From: Simon Kennedy
Sent: 11 May 2017 13:51
To: Karpezo, Marta
Subject: RE: Planning Application APP/16/00379 Land South of, Ranelagh Road, Havant

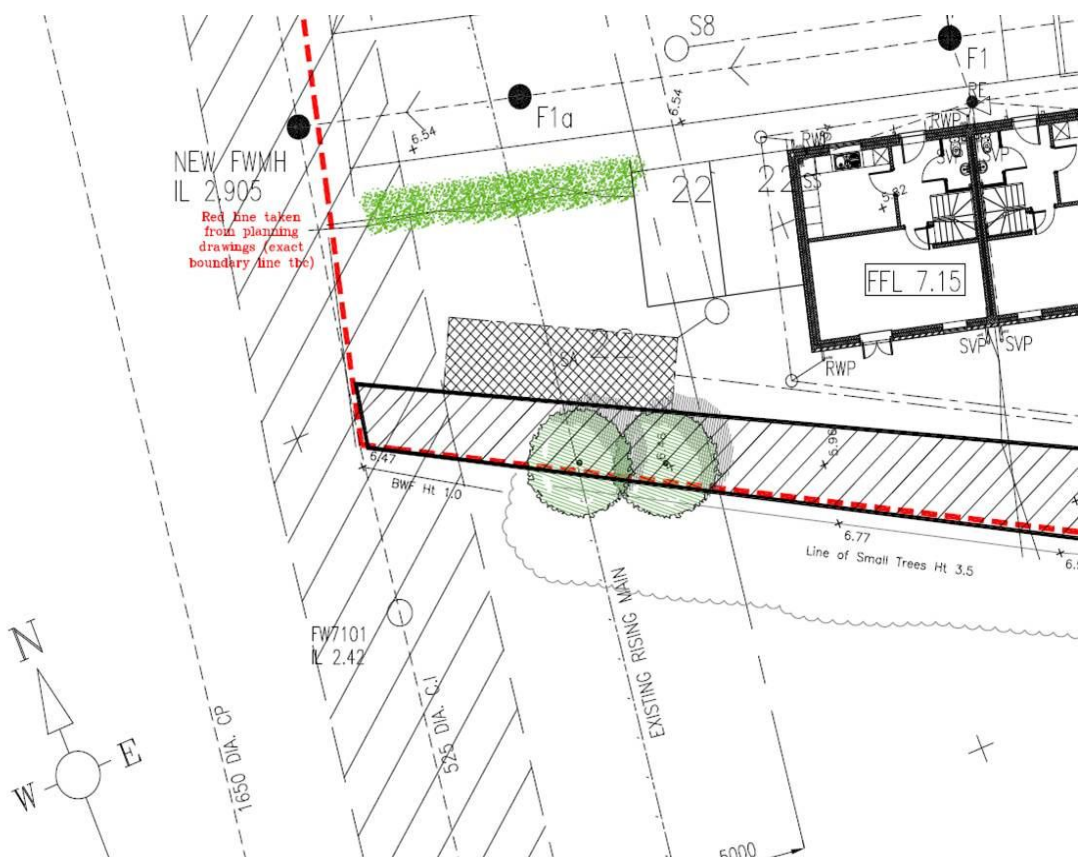
The proposed soakaway is exactly OVER public 600mm critical syphon sewer. Please see below screenshots.

Can you confirm that your comment only relates to the existing mains sewer on the site and the location of a single soakaway in the south-western corner of the site being only 3.5m away from the afore mentioned existing sewer?
